Public Comment No. 237-NFPA 101-2022 [Section No. 18.1.3.11]

**Public Comment No. 86-NFPA 101-2022 [Section No. 18.2.2.2.4]****18.2.2.2.4**

Proposed Change to LSC
18.2.2.2.5.2(3)

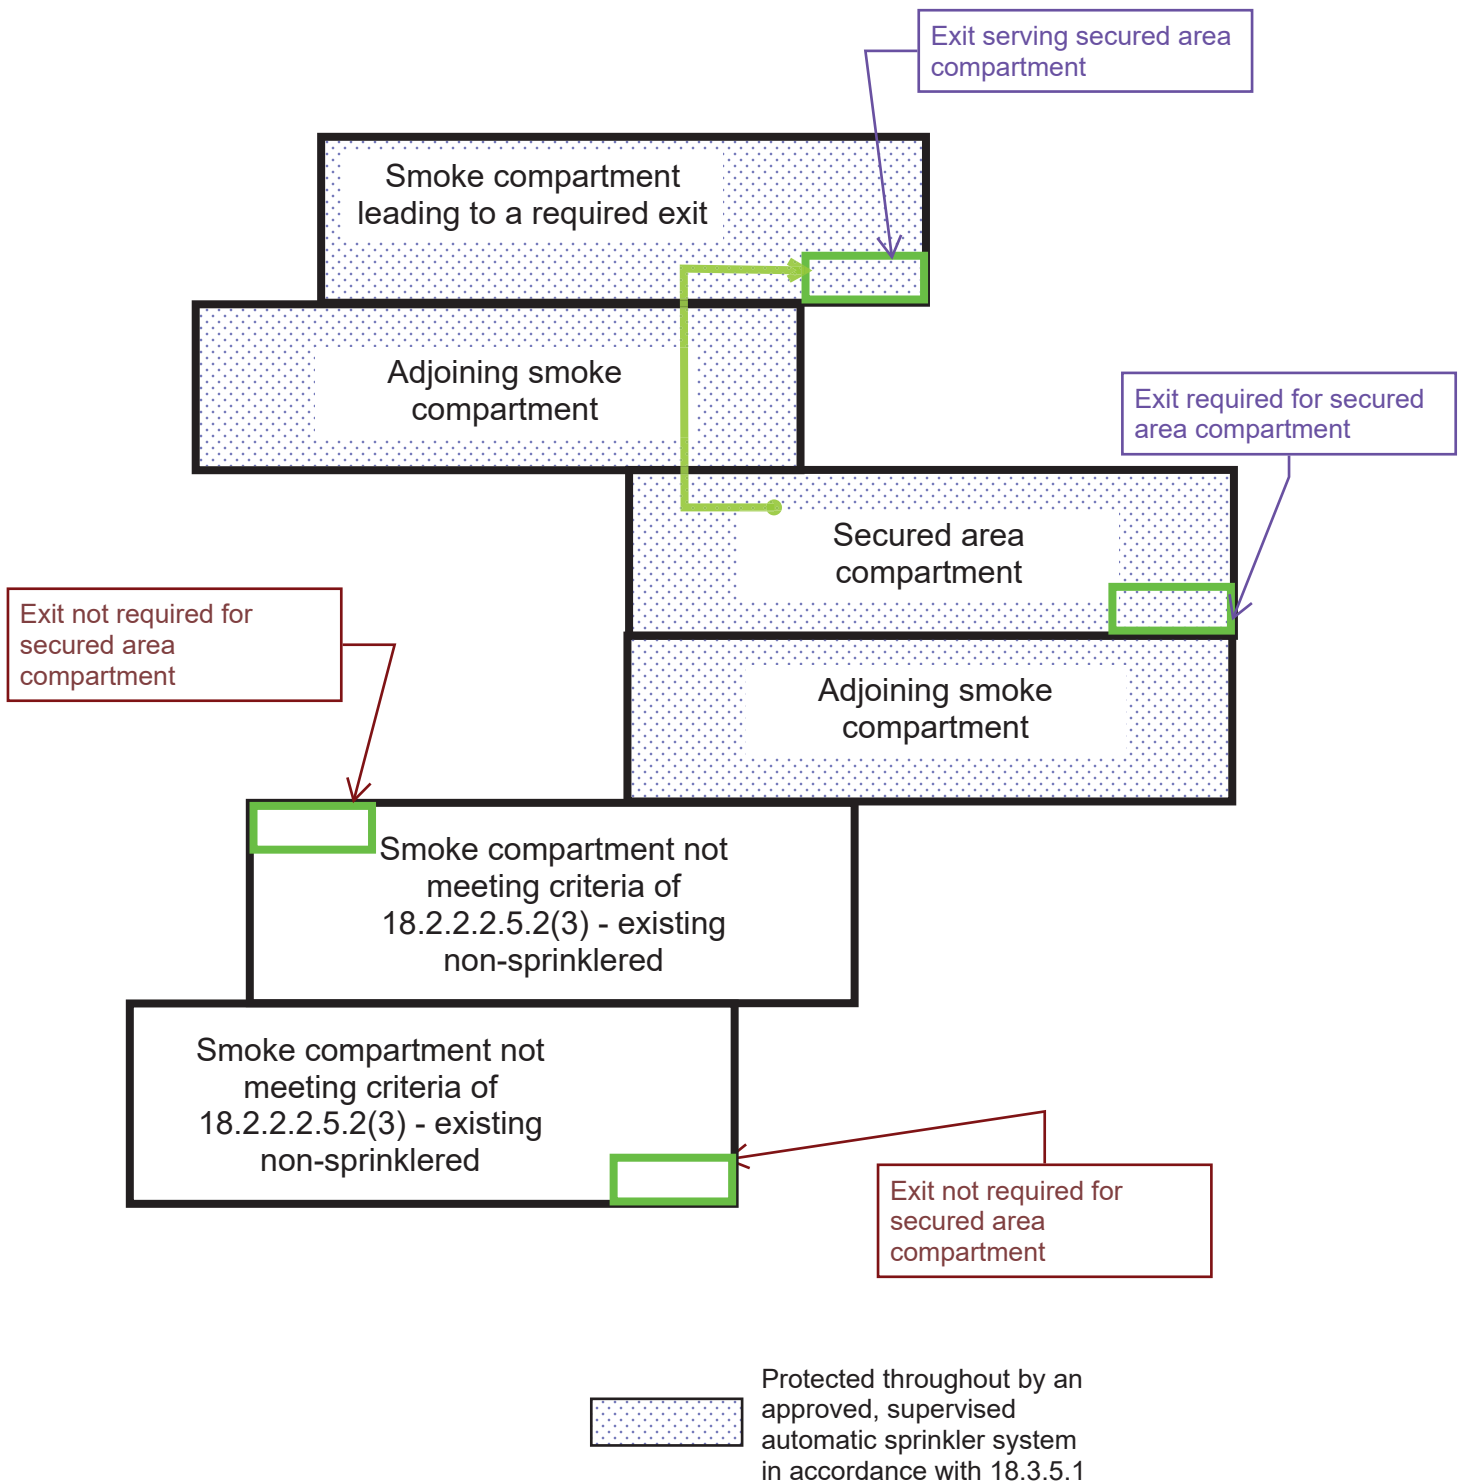
There was some previous email discussion related to the new language in Item #2 with regards to the requirement for sprinkler protection for the smoke compartment, adjacent smoke compartments and all smoke compartments leading to the requires exists. A member of the Task Group submitted a drawing that may be helpful to illustrate this requirement and could possibly be used as handbook material.

As a side note, there was some previous email discussion related to the new language in Item #2 with regards to the requirement for sprinkler protection for the smoke compartment, adjacent smoke compartments and all smoke compartments leading to the requires exists. Ajay Prasad had submitted a drawing that may be helpful to illustrate this requirement and could possibly be used as handbook material. I have attached that drawing for your review.

Committee Action: Rejected but see related SR
Resolution: [SR-6655-NFPA 101-2022](#)
Statement: The revision was developed by a task group on health care door locking to recognize alternative means of providing security where patient special needs require specialized protective measures for their safety.

Proposed Change to LSC
18.2.2.2.5.2(3)

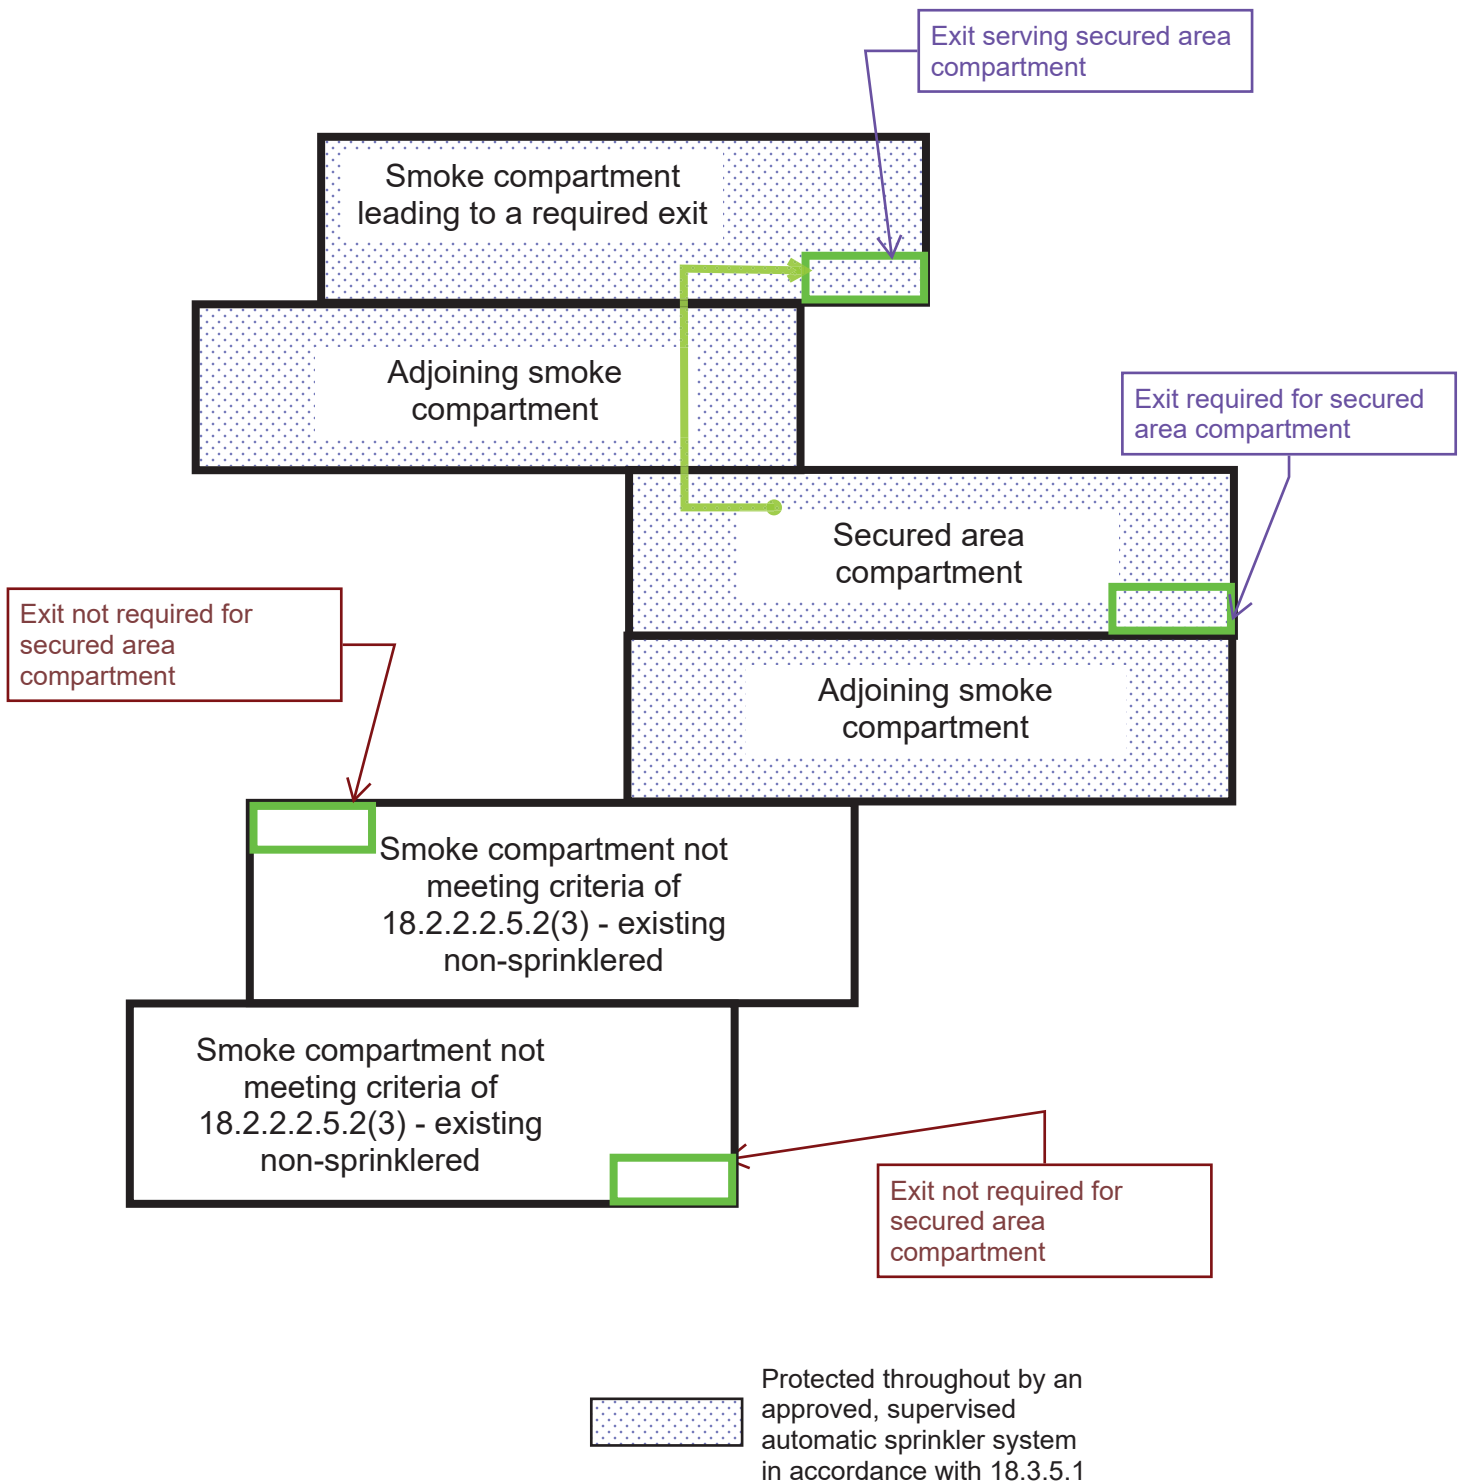
Related to the new language in Item #2 with regards to the requirement for sprinkler protection for the smoke compartment, adjacent smoke compartments and all smoke compartments leading to the requires exists. A task group member submitted a drawing that may be helpful to illustrate this requirement and could possibly be used as handbook material. I have attached that drawing for your review.

As a result of FR-6737 (deleting existing language) and FR-6732 (adding new language), the Task Group felt that 19.2.2.2.5.2 was confusing and proposed a revised re-organization of the section to read as follows. There was some previous email discussion related to the new language in Item #2 with regards to the requirement for sprinkler protection for the smoke compartment, adjacent smoke compartments and all smoke compartments leading to the requires exists. A Task Group member submitted a drawing that may be helpful to illustrate this requirement and could possibly be used as handbook material.

Statement: The revision was developed by a task group on health care door locking to recognize alternative means of providing security where patient special needs require specialized protective measures for their safety.

Figure A.18.2.5.7.2.1(B)(a) All Sleeping Rooms Provided Either with Direct Supervision by Staff or Smoke Detection.

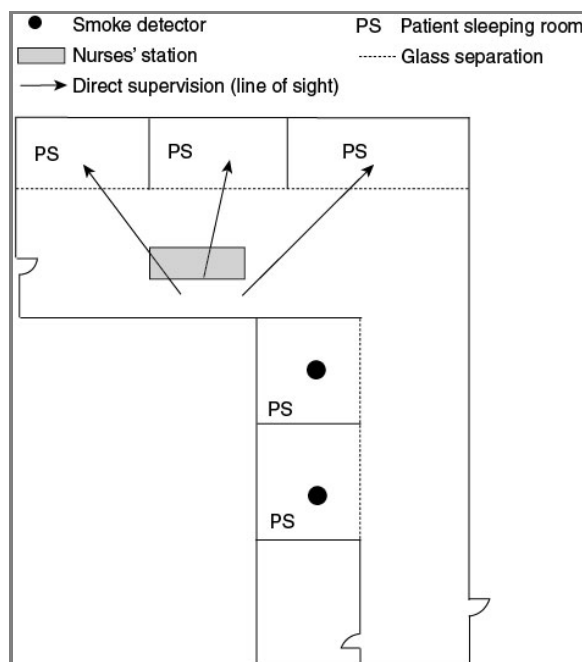
- (1) Direct supervision of all sleeping rooms by staff from a normally attended location within the suite [in accordance with 18.2.5.7.2.1(B)(1)(a)]
- (2) Supervision of those sleeping rooms that can be directly supervised [in accordance with 18.2.5.7.2.1(B)(1)(a)] and smoke detection provided in the sleeping rooms that cannot be directly supervised [in accordance with 18.2.5.7.2.1(B)(1)(b)] as depicted in Figure A.18.2.5.7.2.1(B)(a)
- (3) Total (complete) coverage smoke detection throughout the sleeping suite [in accordance with 18.2.5.7.2.1(B)(2)] as depicted in Figure A.18.2.5.7.2.1(B)(b)

Figure A.18.2.5.7.2.1(B)(c) For Suites >7500 ft² (>700 m²), All Sleeping Rooms Must Be Provided with Direct Supervision by Staff and Total (Complete) Smoke Detection Installed Throughout the Sleeping Suite.

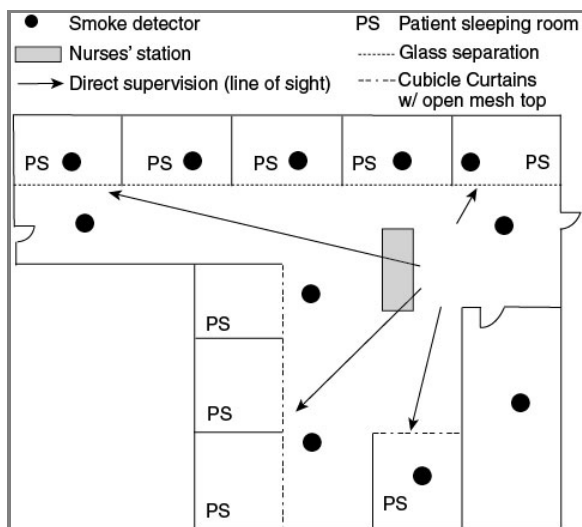
For patient sleeping suites having an area greater than 7500 ft² (700 m²), both direct supervision by staff and total (complete) coverage smoke detection throughout the sleeping suite are required [in accordance with 18.2.5.7.2.3(C)] as depicted in Figure A.18.2.5.7.2.1(B)(c).

Figure A.19.2.5.7.2.1(B)(a) All Sleeping Rooms Provided Either with Direct Supervision by Staff or Smoke Detection.

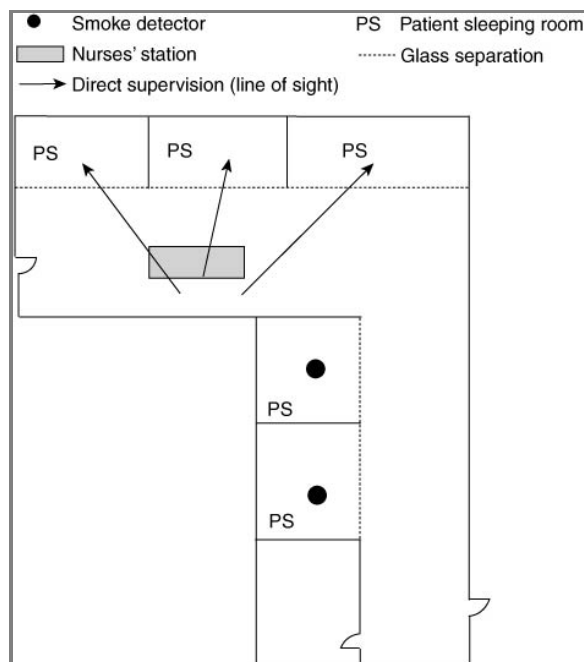
- (1) Direct supervision of all sleeping rooms by staff from a normally attended location within the suite [in accordance with 19.2.5.7.2.1(B)(1)]
- (2) Supervision of those sleeping rooms that can be directly supervised [in accordance with 19.2.5.7.2.1(B)(1)] and automatic smoke detection provided in the sleeping rooms that cannot be directly supervised [in accordance with 19.2.5.7.2.1(B)(2)] as depicted in Figure A.19.2.5.7.2.1(B)(a)
- (3) Total (complete) coverage automatic smoke detection throughout the sleeping suite [in accordance with 19.2.5.7.2.1(B)(2)] as depicted in Figure A.19.2.5.7.2.1(B)(b)

Figure A.19.2.5.7.2.1(B)(c) For Suites $>5000 \text{ ft}^2$ ($>460 \text{ m}^2$) and $\leq 7500 \text{ ft}^2$ ($\leq 700 \text{ m}^2$) Protected by Standard Response Sprinklers, Total (Complete) Smoke Detection Required Throughout the Sleeping Suite.

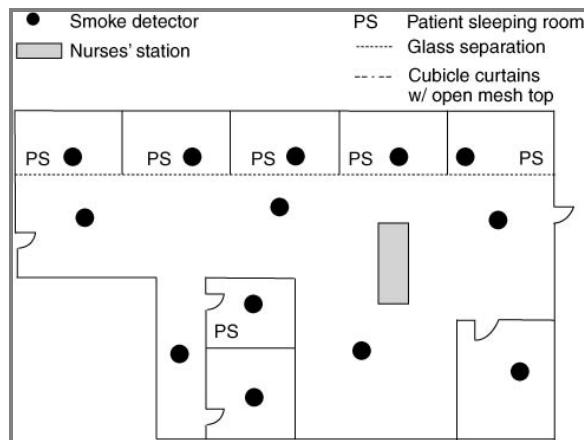
For patient sleeping suites having an area greater than 5000 ft² (460 m²) but not greater than 7500 ft² (700 m²), sprinkler protection is required throughout the suite and the supervision requirements of 19.2.5.7.2.1 also apply. Such protection might take the form of standard-response sprinklers in accordance with 19.3.5.7 or quick-response sprinklers in accordance with 19.3.5.8. Where standard-response sprinklers are used in accordance with 19.3.5.7, the suite must be protected by total (complete) automatic smoke detection [in accordance with 19.2.5.7.2.3(B)(1)] as depicted in Figure A.19.2.5.7.2.1(B)(c).

Figure A.19.2.5.7.2.1(B)(d) For Suites $>7500 \text{ ft}^2$ ($>700 \text{ m}^2$), All Sleeping Rooms Must Be Provided with Direct Supervision by Staff and Total (Complete) Smoke Detection Installed Throughout the Sleeping Suite.

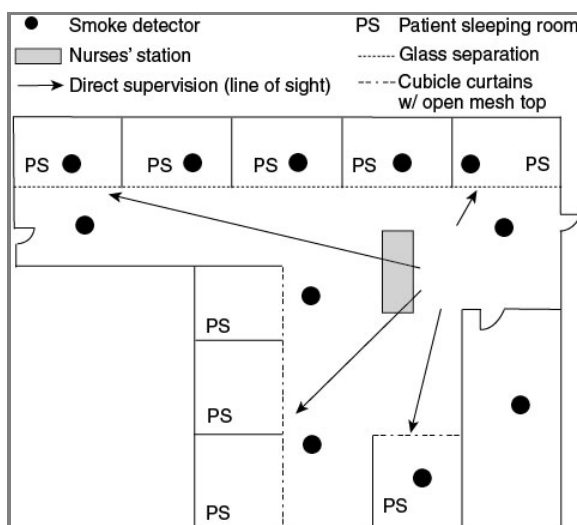
For patient sleeping suites having an area greater than 7500 ft² (700 m²), the suite must be protected by quick-response sprinklers in accordance with 19.3.5.8, direct supervision of all sleeping rooms must be provided by staff, and total (complete) coverage automatic smoke detection must be provided throughout the sleeping suite [in accordance with 19.2.5.7.2.3(C)] as depicted in Figure A.19.2.5.7.2.1(B)(d).
